Central Valley Regional Water Quality Control Board

NOTICE OF APPLICABILITY

**WATER QUALITY ORDER 2015-0121-DWQ
GENERAL WASTE DISCHARGE REQUIREMENTS FOR COMPOSTING OPERATIONS
TRACY DELTA SOLID WASTE MANAGEMENT, INC.
TRACY MATERIAL RECOVERY AND TRANSFER STATION
SAN JOAQUIN COUNTY**

STAFF MEMORANDUM

ATTACHMENT A: Facility Expansion Site Plan (Courtesy EBA Engineering)

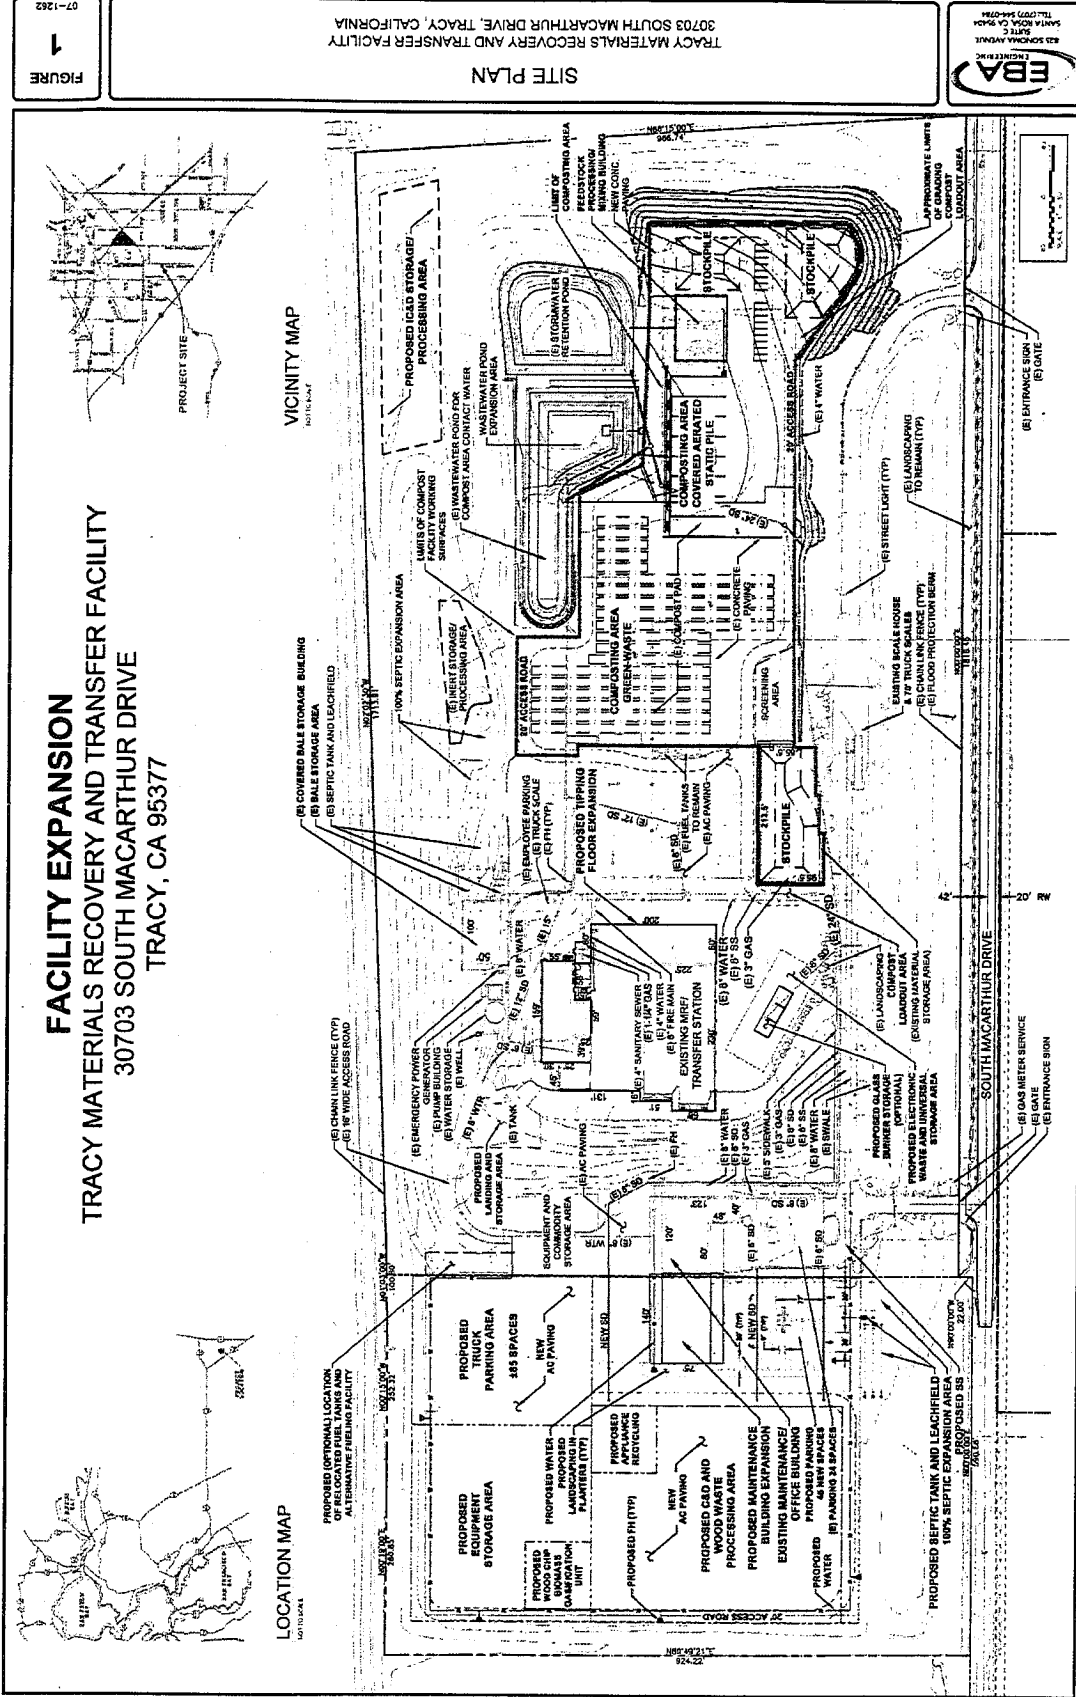
The Facility is located on a 51.7 acre parcel, Assessor Parcel Number 253-130-19, of which 8.4 acres is the permitted compost facility (See Attachment A). Ancillary Facilities that are not subject to the requirements of the General Order include a municipal solid waste Transfer Station, Material Recovery Facility, a mixed construction and demolition debris processing facility, an inert debris processing facility, an administrative office and shop, bale storage building and storage areas, fuel tanks and dispensing, vehicle wash facility, truck and employee parking, water supply well and storage tanks, scalehouse, and truck scales.

ATTACHMENT B: Tracy Compost Facility Process Flow Chart (Source: ROWD Technical Report)

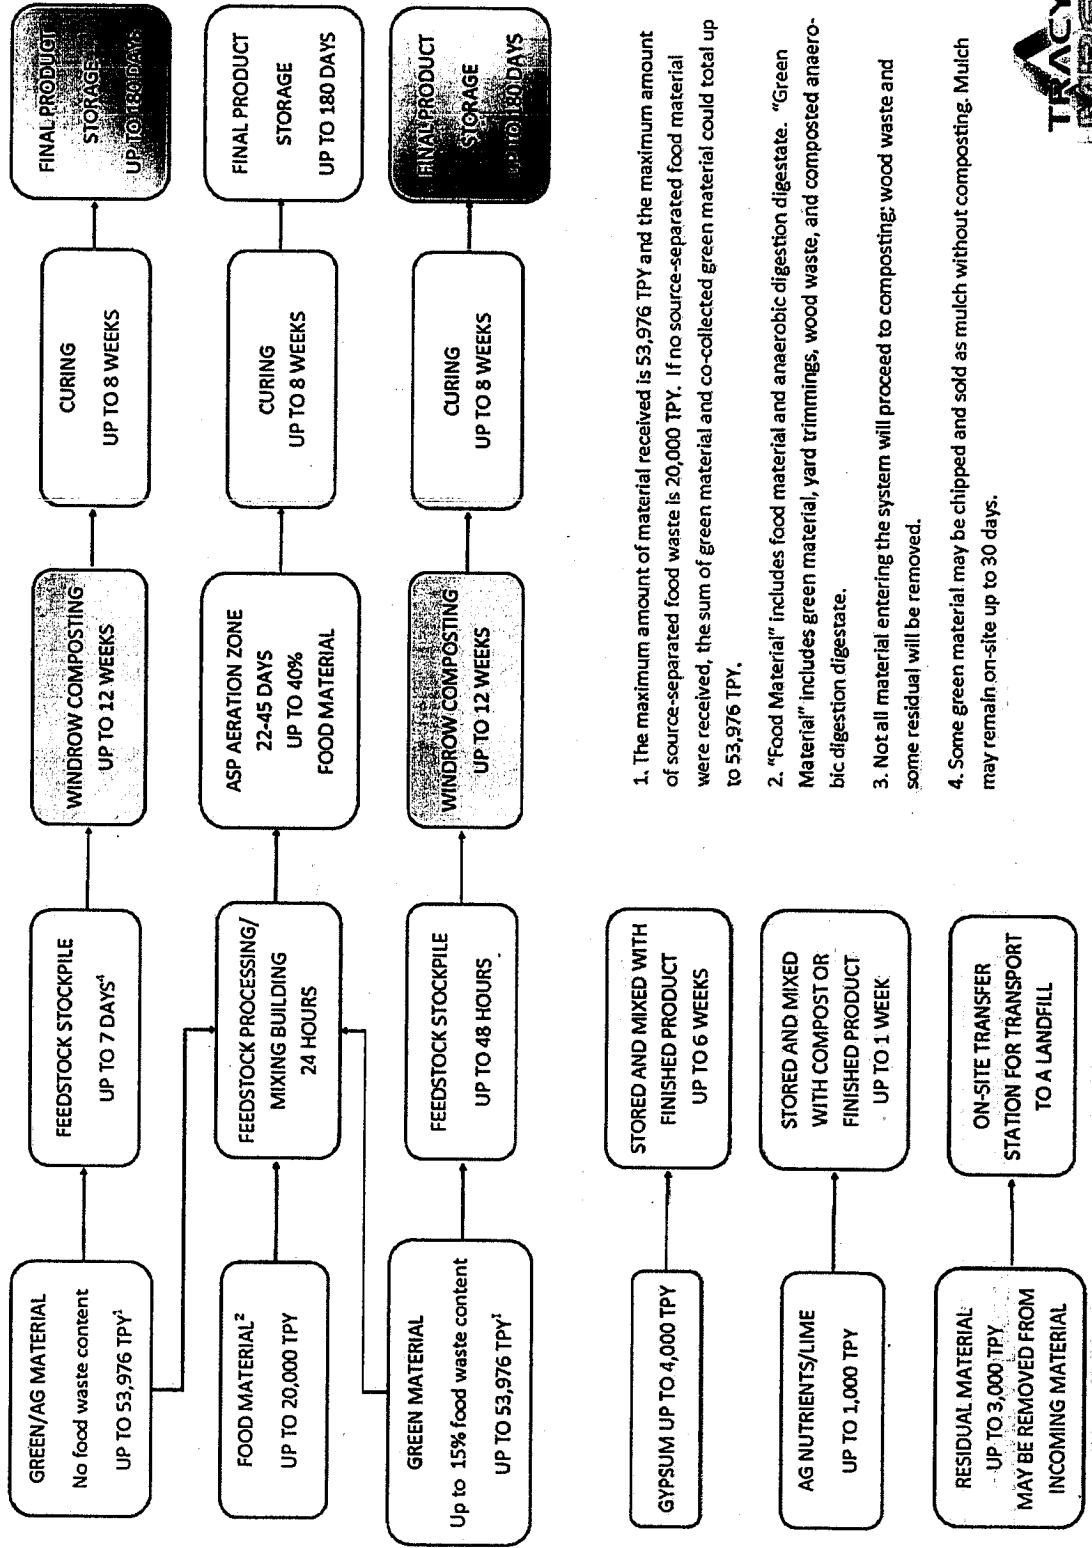
The Facility proposes the use of windrow composting and covered aerated static piles (See Attachment B). The current compost method is windrow composting. Covered aerated static pile (CASP) composting is proposed for future development. The Discharger proposes to use the following feedstocks in its composting operations:

ATTACHMENT C: Wastewater Pond and Working Surface Details (Courtesy EBA Engineering)

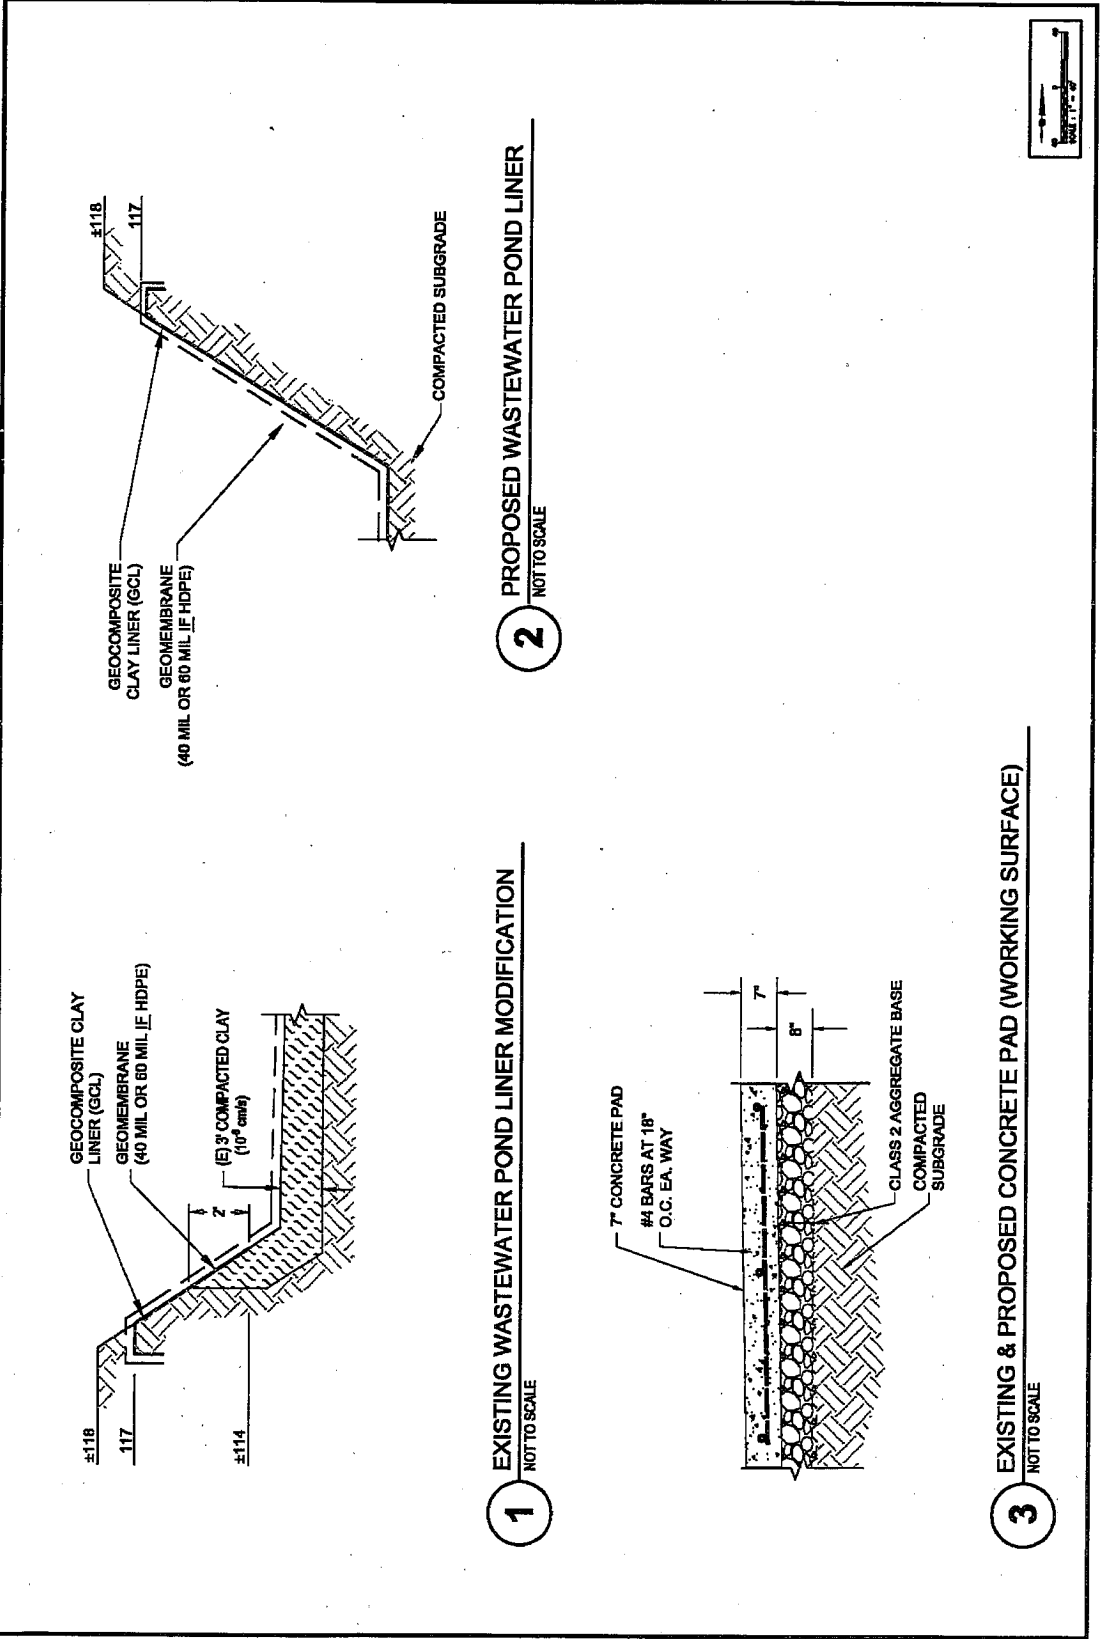
The Discharger stated in the technical report that they shall comply with the General Order requirements for working surfaces used in composting operations including but not limited to designing and constructing such working surfaces with asphaltic concrete or Portland cement concrete. Therefore, all existing and future composting operations shall be conducted on asphaltic concrete or Portland cement concrete (See Attachment C).

- a. The Discharger stated in its technical report that they shall comply with the General Order requirements for its detention pond used in composting operations including but not limited to designing and constructing its expanded detention pond using the following pond liner system (from top to bottom- See Attachment C):

- 1) 40 mil or (60 mil if HDPE) Geosynthetic Geomembrane Liner
 - 2) Geocomposite Clay Liner (GCL)
 - 3) Compacted Subgrade
- b. The Discharger stated in the ROWD that they will install a pan lysimeter below the lowest point of the detention pond capable of effectively monitoring the unsaturated zone below the detention pond bottom. The Discharger has determined that its proposed pan lysimeter design will prevent any leakage from the detention pond bottom in close proximity to the pan lysimeter from bypassing the pan lysimeter. The Discharger's proposed design for the pan lysimeter at a minimum consists of the following components (from top to bottom):

- 1) 8-inch thick sand layer or equivalent to prevent pond leakage bypass;

- 2) 4-inch diameter schedule 80 PVC pipe riser (perforated bottom); and
 - 3) 60-mil HDPE geomembrane sheet formed as a pan of sufficient depth to retain captured leakage from the detention pond.
